| 1.2 PCN No. | | ADG/21/12838 |
| 1.3 Title of PCN | | L9680x, L9679x (UAF3, UAI3): Super High Density (SHD) NEAP Lead-Frame Introduction |

UAF3/L9680 and UAI3/L9679 TQFP14x14 100L EP in Muar Migration to SHD Line

Strip size comparison

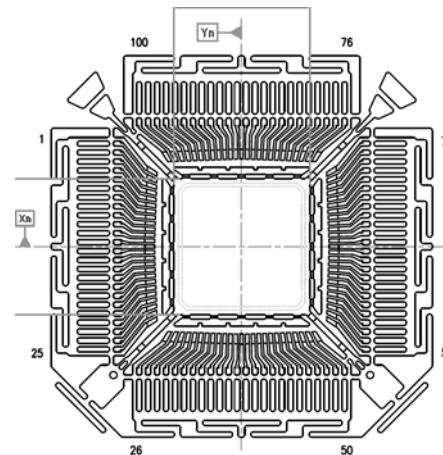
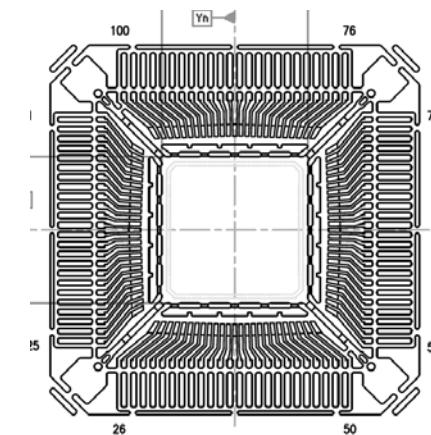
Matrix
2 x 8
16 units

SHD
4 x 12
48 units

No changes in unit geometry. Only change strip size

Mold Injection Gates

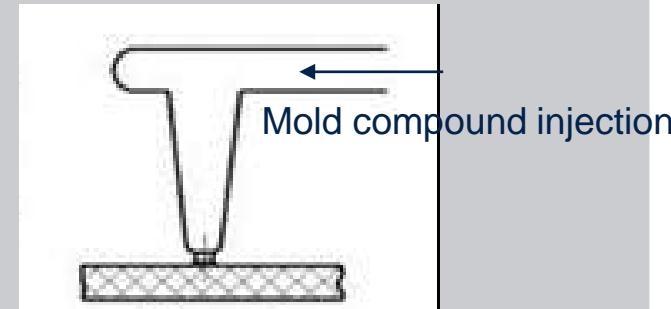
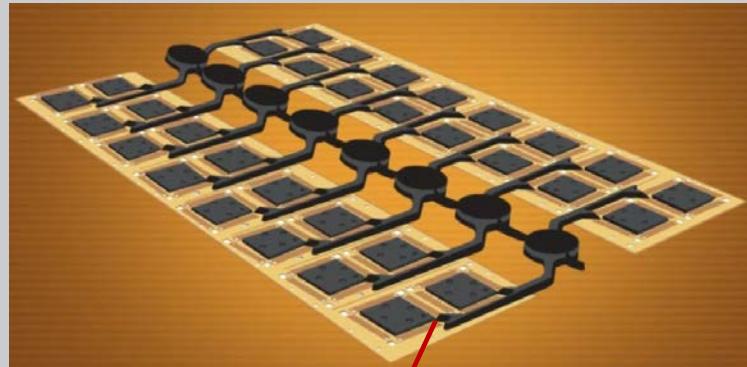
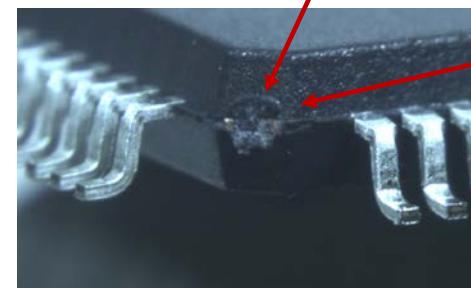
Same Basic Technology - Transfer Molding

SIDE GATE INJECTION

Gate Injection Notch

**Wire sweeping reduction
with Top Central Gate**
